BRITISH GLIDING ASSOCIATION

TECHNICAL COMMITTEE

TNS 7/8/80

1. AIRWORTHINESS "AGGRO"

Subject: Examination of the canopy lock

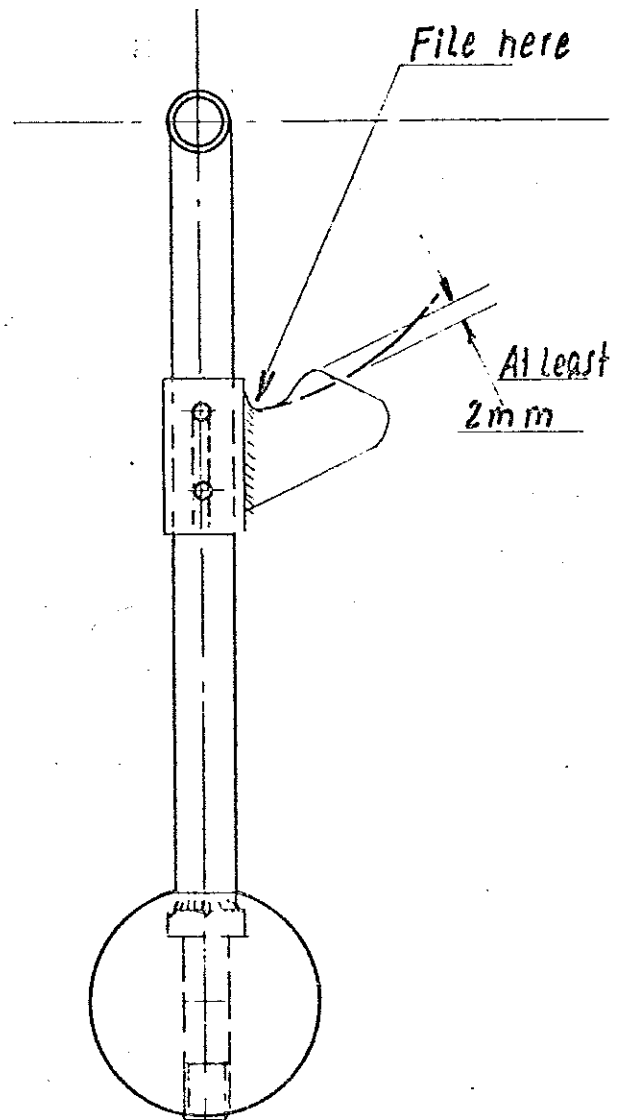
Instruction: The canopy lock has to be examined if the cam is at least 2 mm high.
 If not, take a file to make it deeper.
 Note the examination in the log book.

FIG. 1

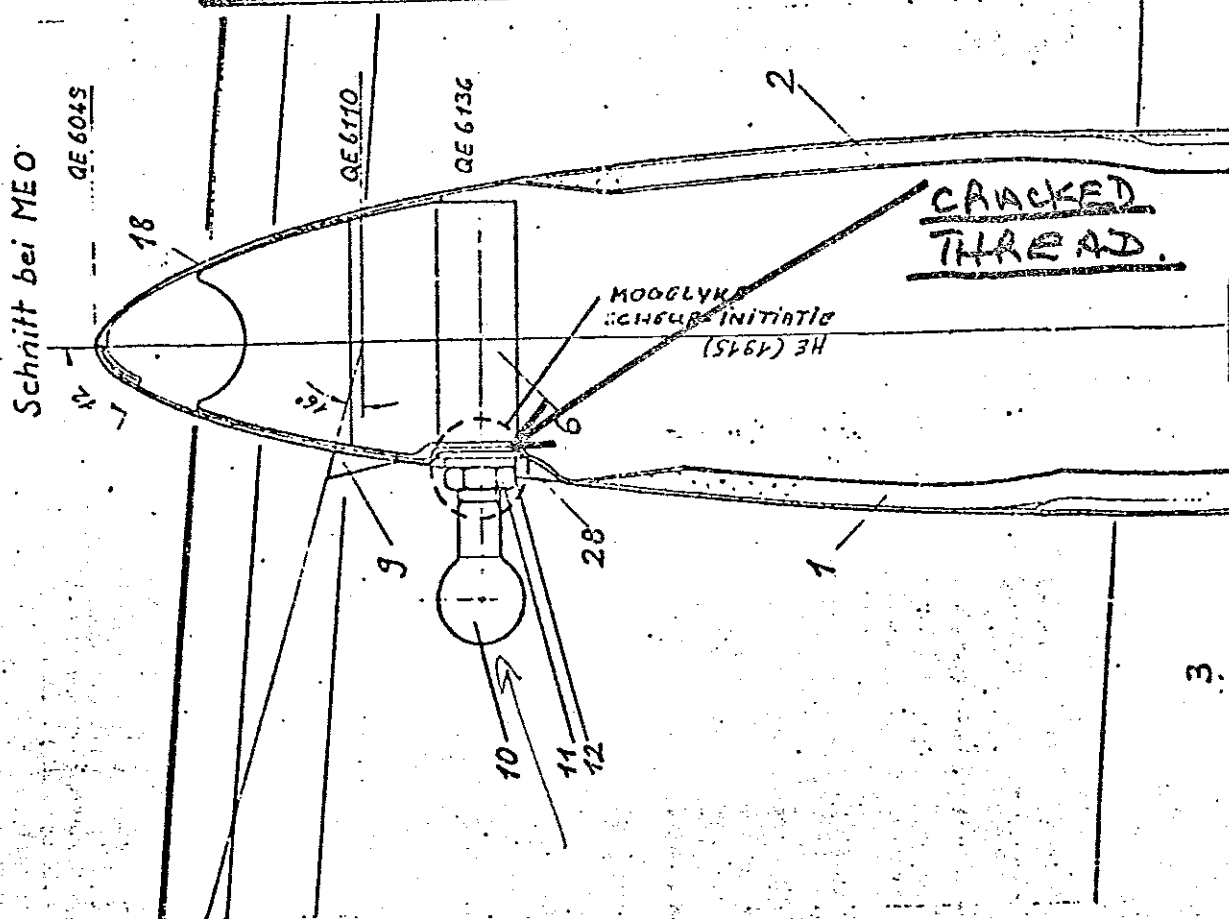
- 1.4. Astir - Tailplane Front Attachment Ball Cracked. Three out of eighteen samples inspected by Dutch Airworthiness Authority were found to be cracked at first thread under the nut, (tenth from end of bolt). May require X 50/100 magnifier to detect this damage (sketch attached).
